## **Town of Arlington, MA Redevelopment Board**

### **Agenda & Meeting Notice July 6, 2020**

##### **Docket #3602, 1207-1211 Mass Ave**

##### **Docket #3625, 882-892 Mass Ave**

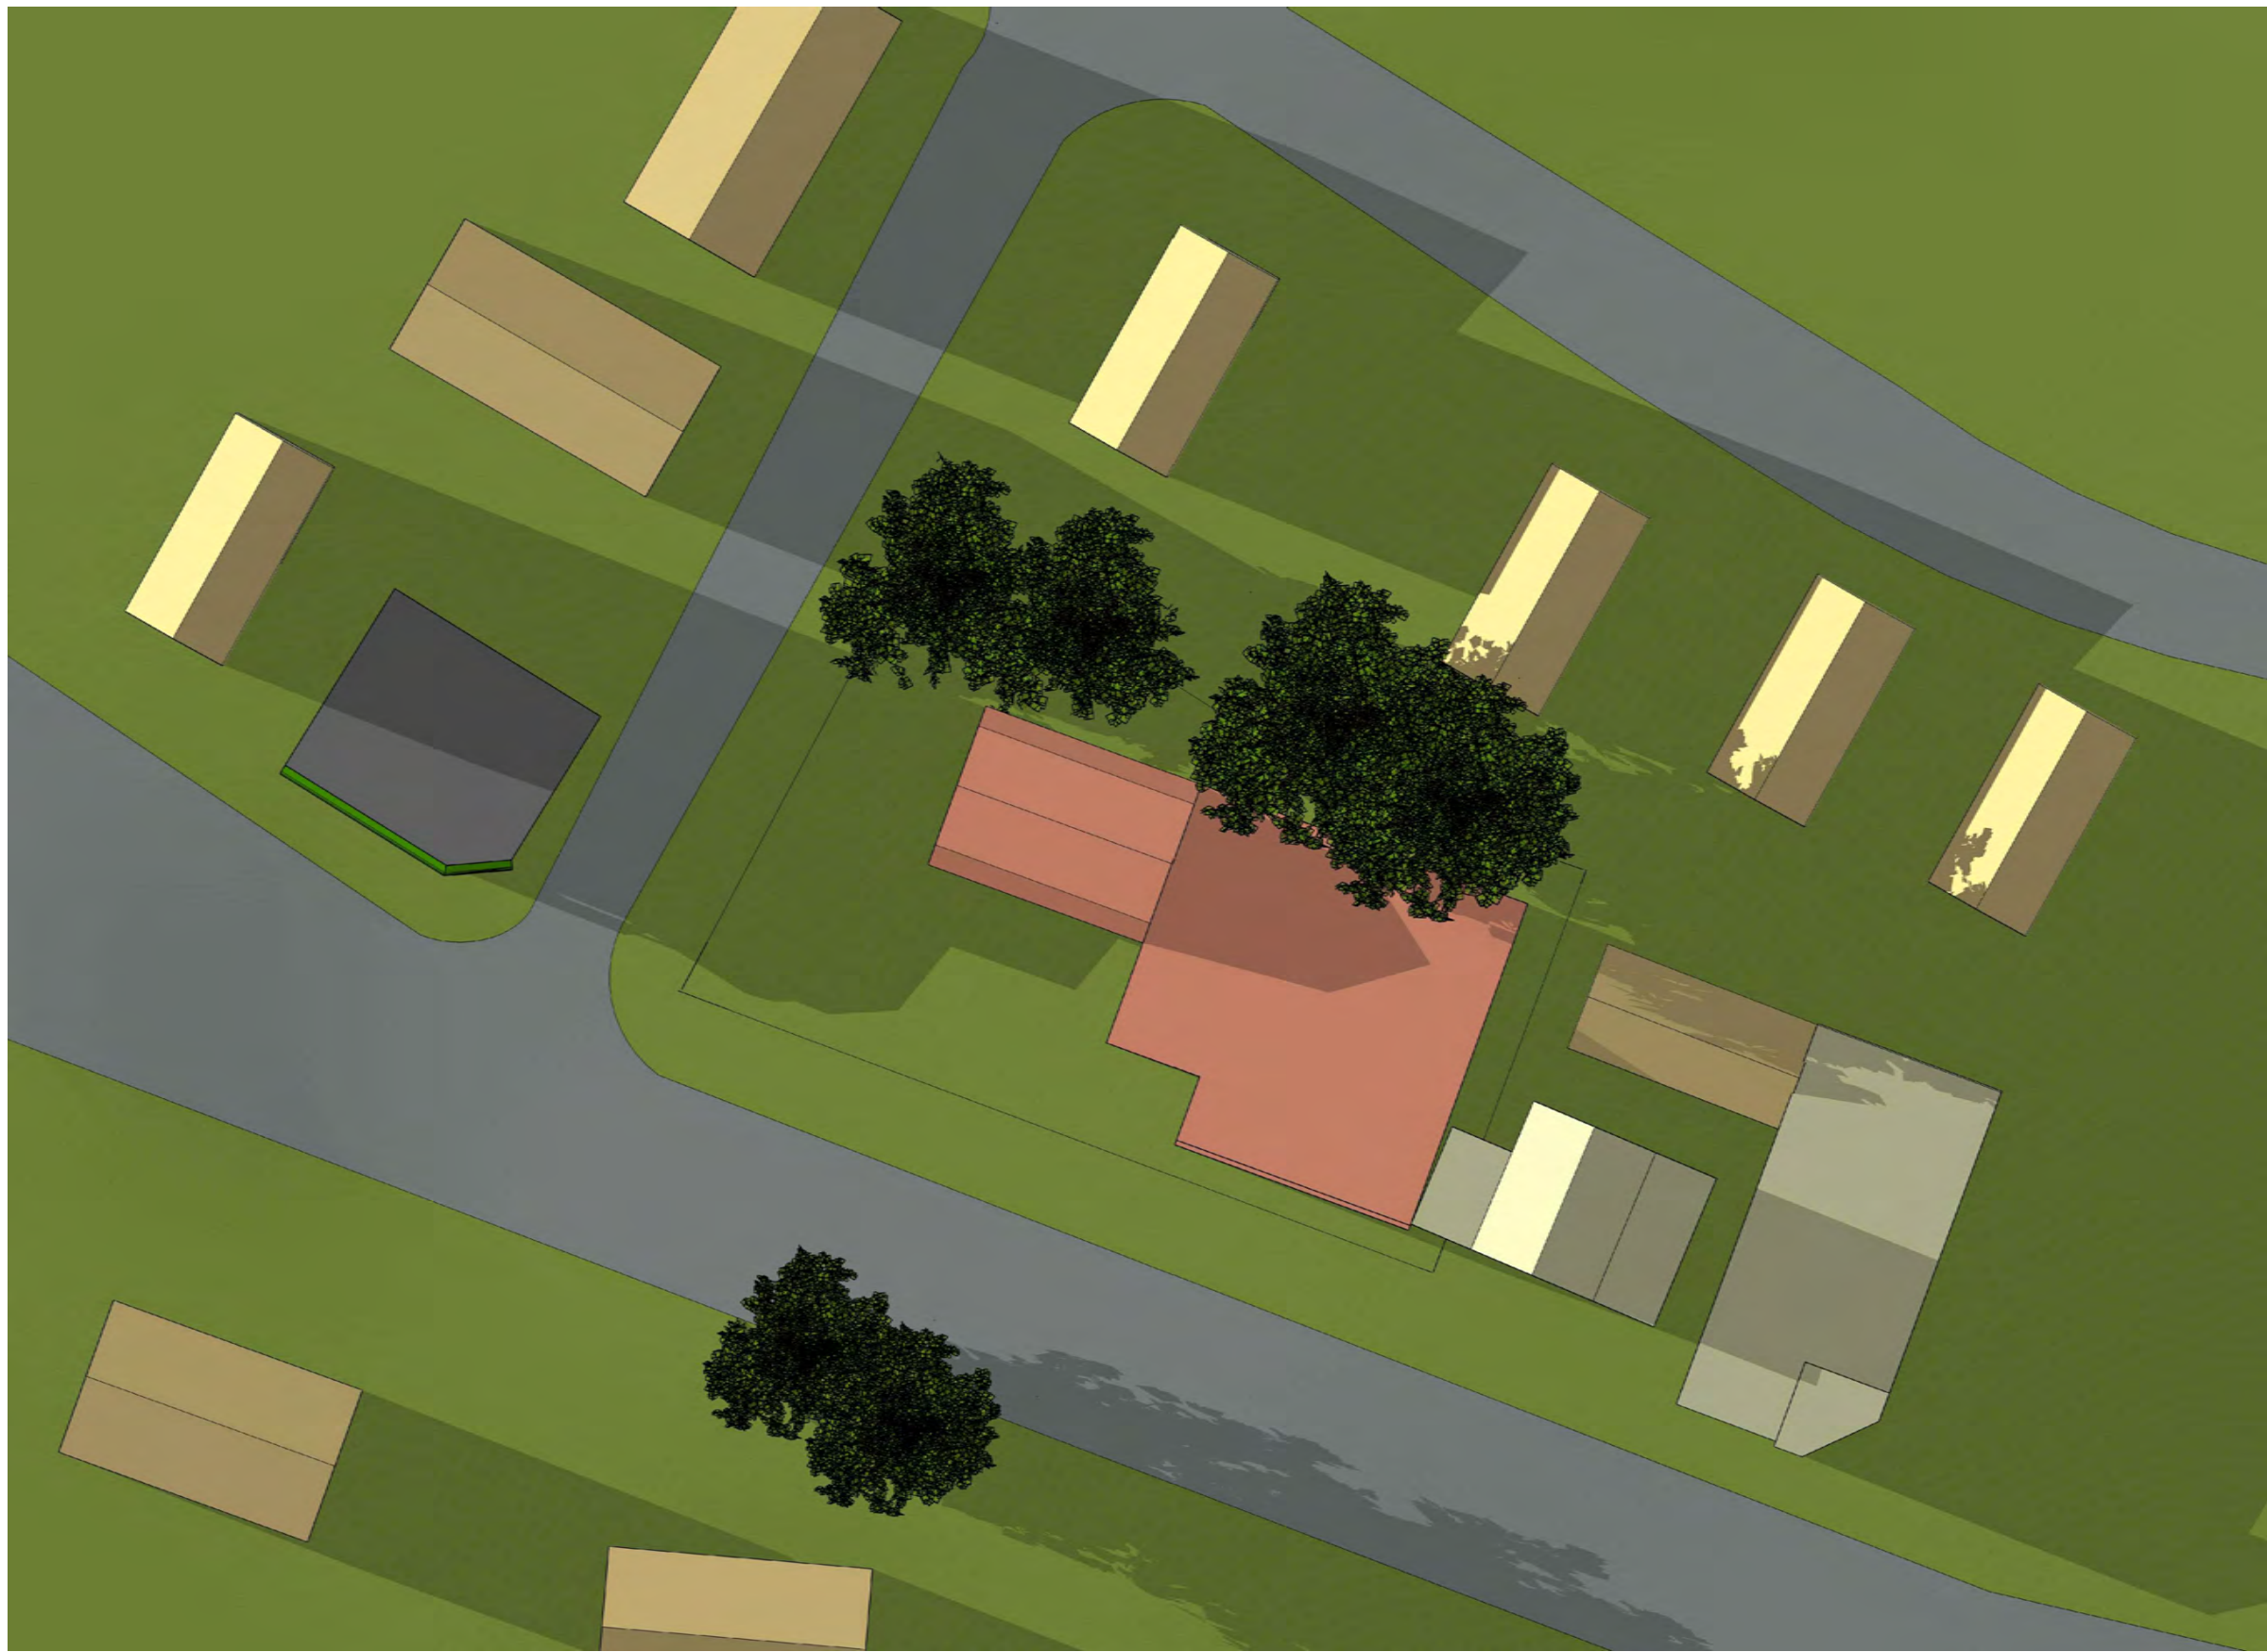
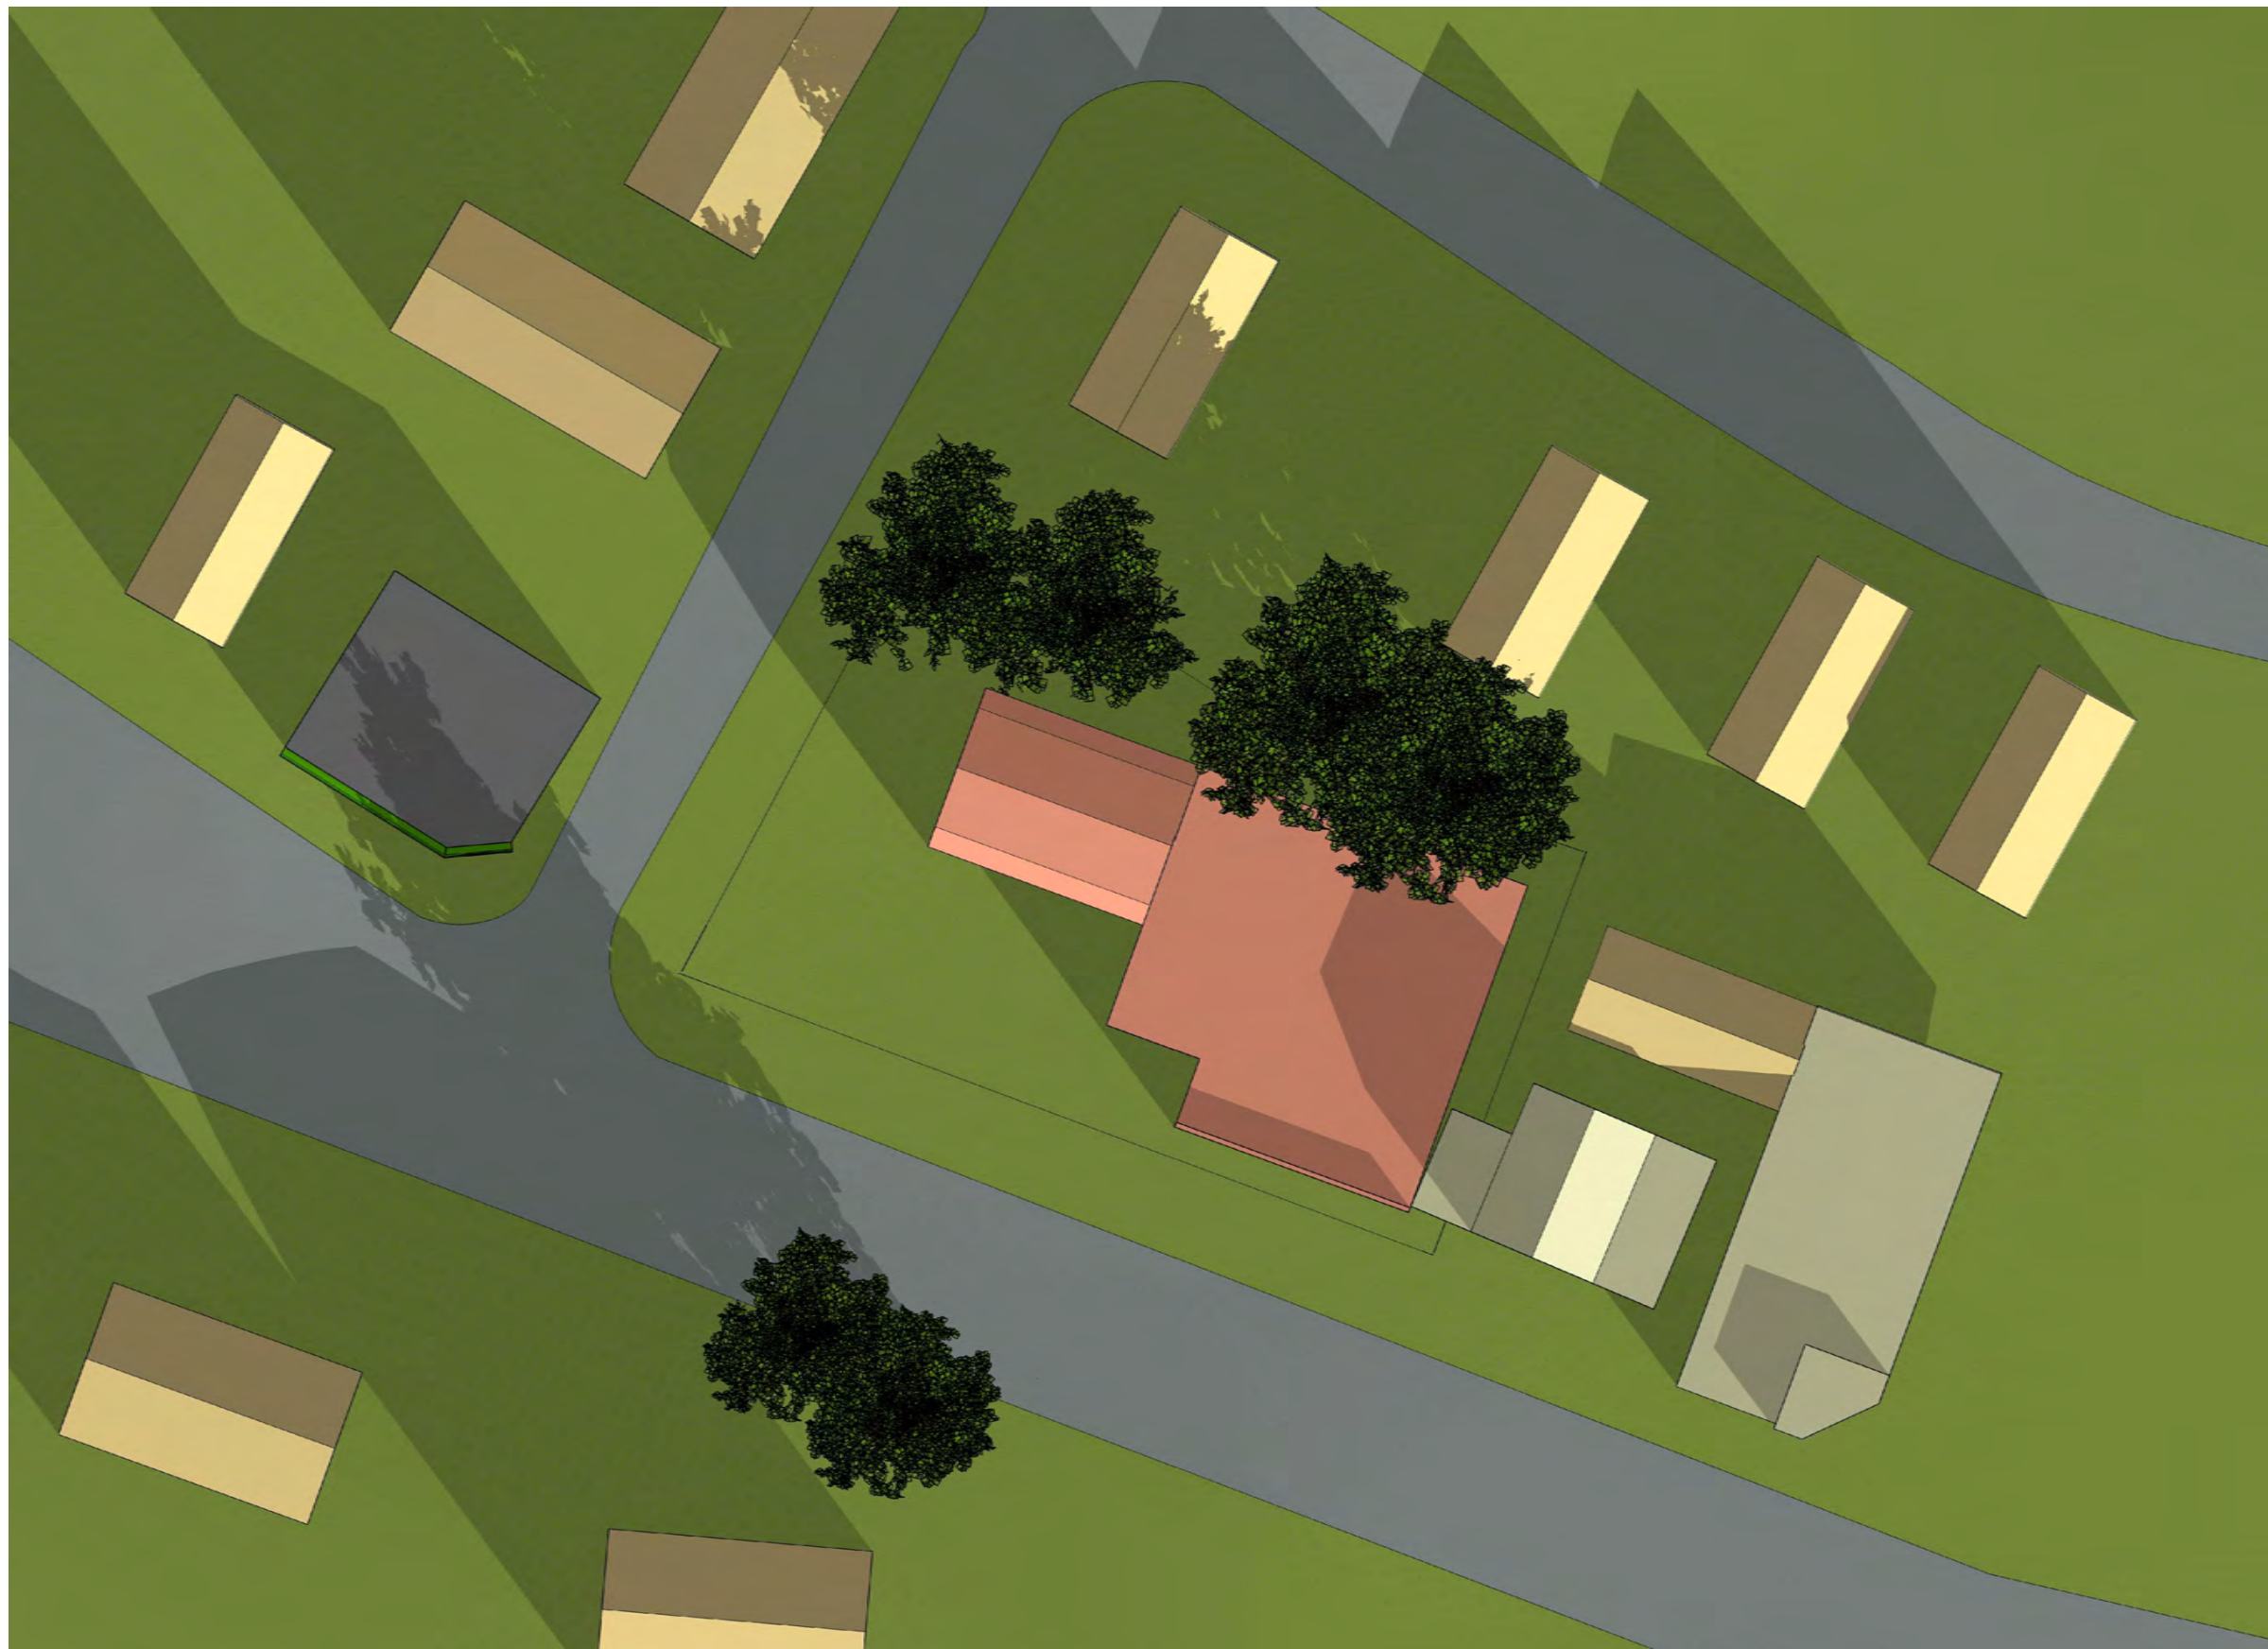
7. Re-evaluate the shadow study previously submitted to consider the existing shadows and provide a comparison and determine any impact to solar arrays in the neighborhood.

7. Take another look at your shadow study, consider the existing shadows and provide a comparison and determine any impact to solar arrays in the neighborhood;

*The plan set includes an updated shadow study based on the new building. The plan set also includes a shadow study documenting the existing conditions of the building and shows trees at the rear of the site.*

*The plan set includes an updated shadow study based on the new building. The plan set also includes a shadow study documenting the existing conditions of the building and shows trees at the rear of the site. The updated materials do not identify if any of the adjacent buildings have solar arrays installed.*
